SUBJECT: MILLSTONE POWER STATION, UNITS 2 AND 3 - STAFF ASSESSMENT OF INFORMATION PROVIDED PURSUANT TO TITLE 10 OF THE *CODE OF FEDERAL REGULATIONS* PART 50, SECTION 50.54(f), SEISMIC HAZARD REEVALUATIONS FOR RECOMMENDATION 2.1 OF THE NEAR-TERM TASK FORCE REVIEW OF INSIGHTS FROM THE FUKUSHIMA DAI-ICHI ACCIDENT (TAC NOS. MF3968 AND MF3969)

STAFF ASSESSMENT BY THE OFFICE OF NUCLEAR REACTOR REGULATION

RELATED TO SEISMIC HAZARD AND SCREENING REPORT

MILLSTONE POWER STATION, UNITS 2 AND 3

Figure 3.3-1 Plot of Staff's and Licensee's Base Case Shear-Wave Velocity Profiles for MPS2 and MPS3

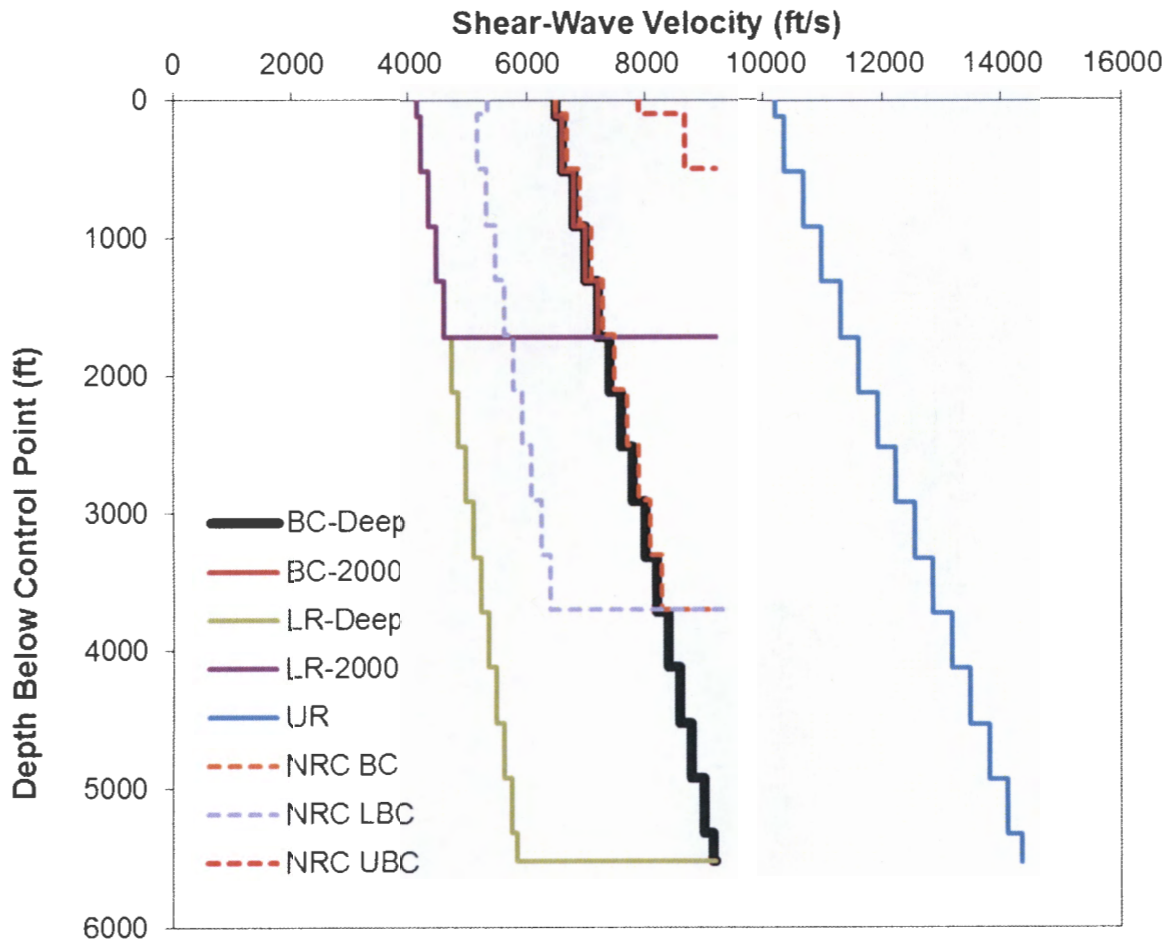
As described above, the licensee used multiple geophysical methods to characterize the shear wave velocity in the upper 100 to 115 ft. [30 – 35 m] of the site. As such, the NRC staff used the same best estimate velocity profile as that used by the licensee. In order to characterize the uncertainty in the shear wave velocity, the NRC staff developed lower and upper velocity profiles. Because the NRC staff considered the MPS site to be fairly well characterized, the NRC staff used a log normal standard deviation of 0.15 over the upper 100 ft. [30 m] to develop the lower and upper base case velocity profiles. Below 100 ft., the NRC staff increased the log normal standard deviation to 0.2 to reflect a larger degree of uncertainty. The NRC staff did not use a greater standard deviation below 100 ft. [30 m] to prevent a large artificial impedance contrast at that depth. The NRC staff used a linear velocity gradient below 100 ft. [30 m] with the depth to reference rock at 3700 ft. [1128 m] for the base case and lower base case velocity profiles. For the upper velocity profile, using the velocity gradient resulted in a total profile thickness of 500 ft. [152 m] before reaching reference rock. Because the depth to reference rock varied significantly between the base case and upper case profile, the NRC staff did not implement any additional uncertainty for the depth to reference rock. Figure 3.3-1 of this assessment shows a comparison of the staff's and licensee's base case velocity profiles for the MPS site. As shown in Figure 3.3-1, the staff's lower and upper velocity profiles are closer to the middle or best estimate base case profile than the licensee's lower and upper profiles.

Figure 3.3-2 Plot Comparing the Staff's and the License's Median Amplification Functions and Uncertainties for one input loading level for MPS2 and MPS3

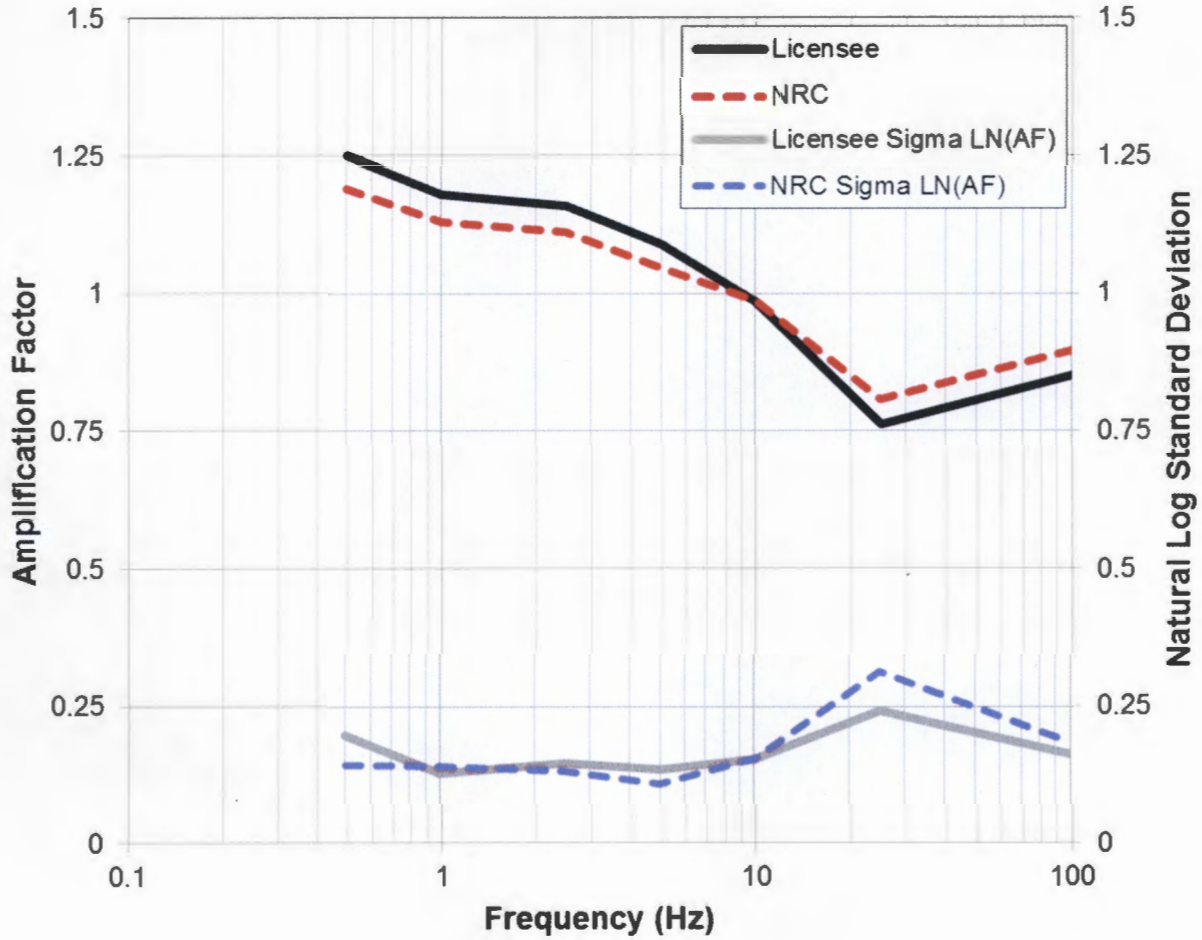
Figure 3.3-2 of this assessment shows a comparison of the staff's and licensee's median site amplification functions and uncertainties (log normal standard deviation) for one of the eleven input loading levels. The results from this one loading level are typical of other loading levels, and there is only moderate difference in amplification at frequencies greater than 20 Hz as the loading level increases due to modeling the rock behavior as linear.

Figure 3.3-3 Plot Comparing the Staff's and the Licensee's Mean Control Point Hazard Curves at a Variety of Frequencies for MPS2 and MPS3

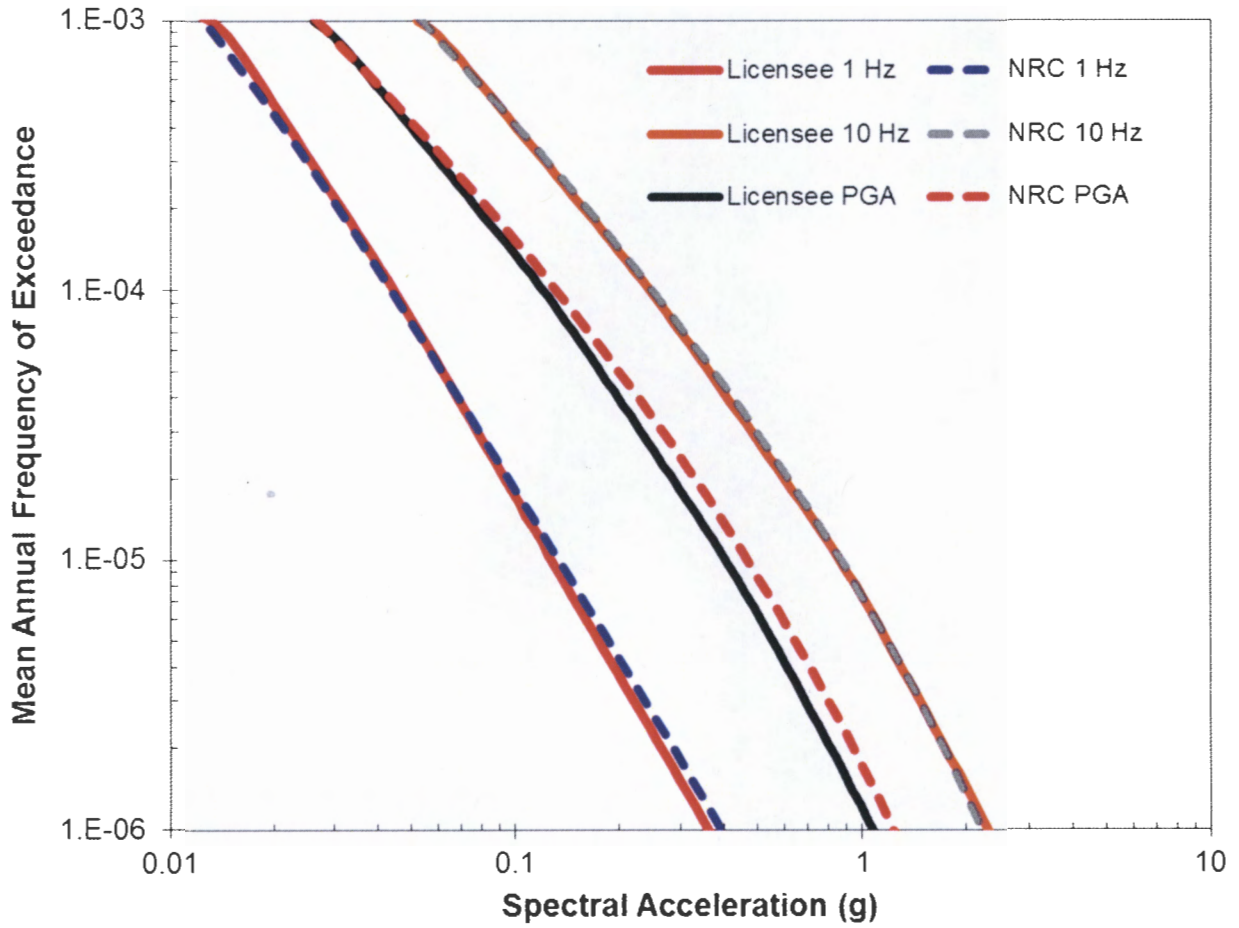
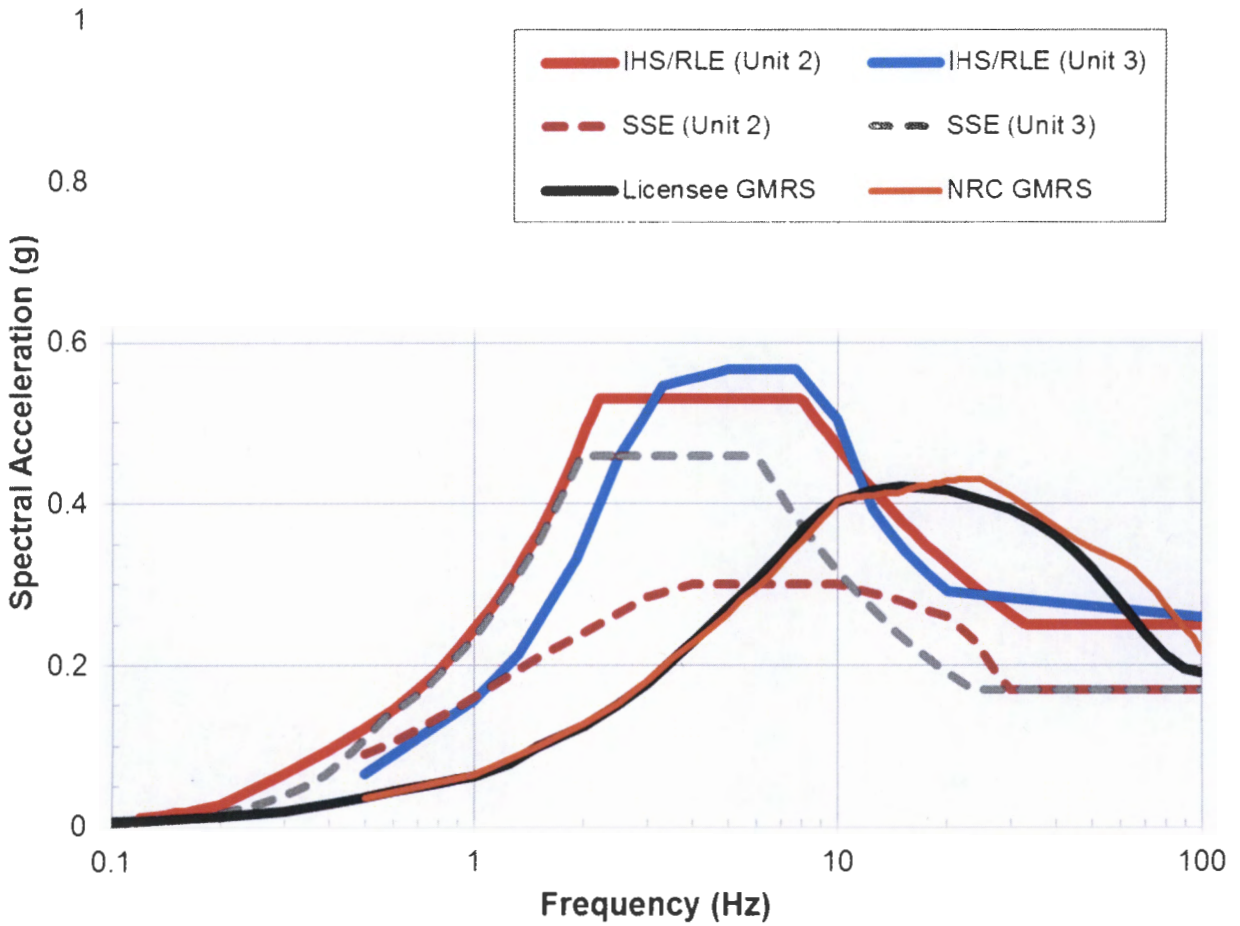
Overall, the licensee's approach to modeling the subsurface rock properties and uncertainty results in similar site amplification factors and standard deviation of the amplification factor. Therefore, as shown in Figure 3.3-3 of this assessment the control point seismic hazard curves and the resulting GMRS, as discussed below are similar. Because the licensee followed the

guidance in the SPID for its site response analysis, these differences are acceptable to the NRC staff. Appendix B of the SPID provides guidance for performing site response analyses, including capturing the uncertainty for sites with less subsurface data; however, the guidance is neither entirely prescriptive nor comprehensive. As such, various approaches in performing site response analyses, including the modeling of uncertainty, are acceptable for the response to the 50.54(f) letter.
